DESCRIPTIVE REPORT

Registry No. H-10949

Sublocality Snow Passage and Approaches

Descriptive Report to Accompany Hydrographic Survey H10949

Figure 2: Survey junction with H10949

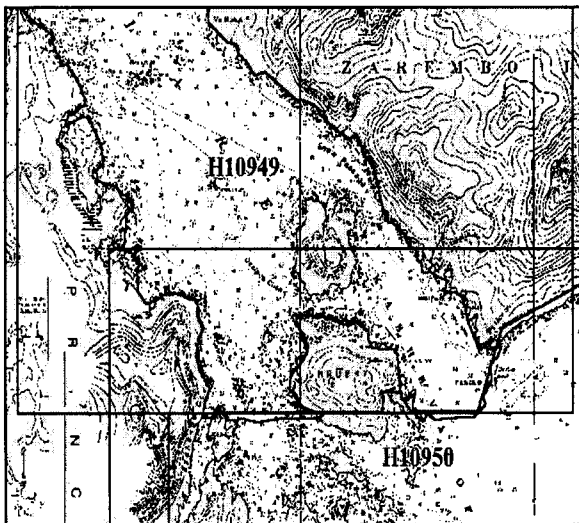
Survey H10950 compares very well with this survey at the junction, with differences generally one fathom or less. Final comparisons will be made at the Pacific Hydrographic Branch (PHB) after the application of smooth tides. *Junction with this survey is complete.*

Figure 3: SWMB coverage gap west of Shrubby Island

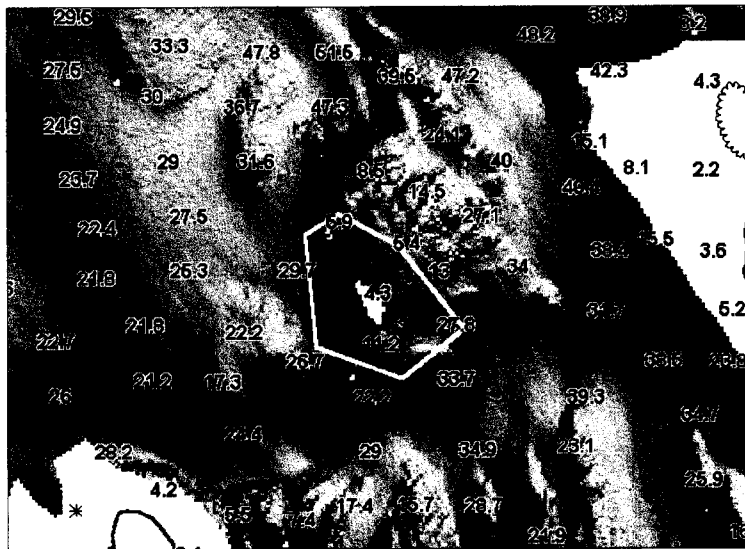
Approximately 600 meters west of the northwestern tip of Shrubby Island at 56°14' 27.12"N, 133°00' 58.37"W (622944.4 E, 6234657.7 N), is a holiday approximately 30 meters by 80 meters in size. Depths surrounding the pinnacle are on the order of 20 meters with the shoalest depth measured being 4.3 meters. *(2.5 fms based on approved tide)* Examination of the rejected outer beams of the SWMB data indicate that the shoalest depth is 7 cm shoaler than the shoalest accepted sounding. Possible traffic in this area which could be affected by this coverage gap would be fishing vessels with a size on the order of 30 to 40 feet. Larger vessels tend to transit the region on the eastern shore of Shrubby Island. *The density of the soundings compiled as shown on the SS is adequate to portray the coverage of the shoal area located during this survey.*

Figure 4: SWMB holiday in Snow Passage

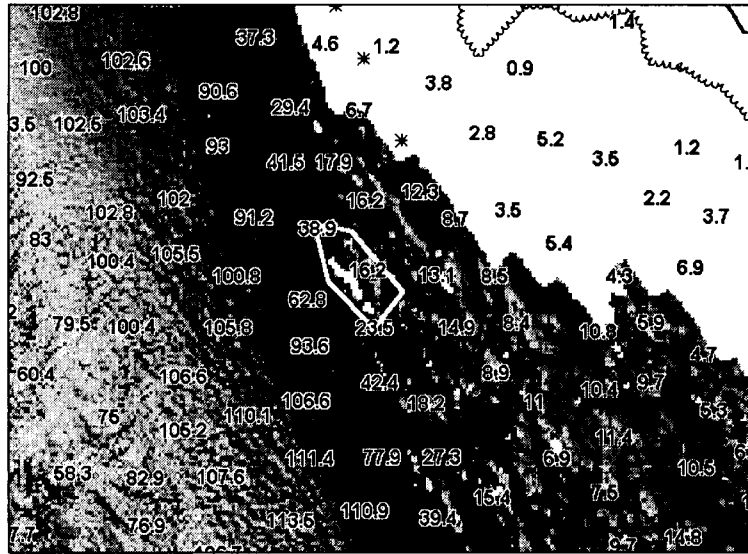
At the southeastern edge of Snow Passage, at 56°15'57.2"N, 132°56'30.62"W (627,469.8E 6,237,577.3N) is a holiday approximately 22 meters wide and 120 meters long, with surrounding soundings of approximately 60 meters seaward and 15 meters shoreward. Examination of this holiday reveals no indication of shoaler soundings in this region. It appears to be a breakpoint where the gentle shoreward slope meets the cliff face that falls toward the submarine canyon at the pass. It is the Hydrographer's opinion that no shoaling exists in this gap; however it is noteworthy due to its proximity to a heavily trafficked passage. In this instance, outer beams from SWMB past 60° beyond nadir were accepted in an attempt to fill the hole. These outer beams were accepted in CARIS line mode and then reexamined in subset mode to ensure data quality.

Concur. The density of soundings compiled in this area based on the scale of the survey is adequate enough to delineate and portray the steep bottom configuration along the southeastern edge of Snow Passage.
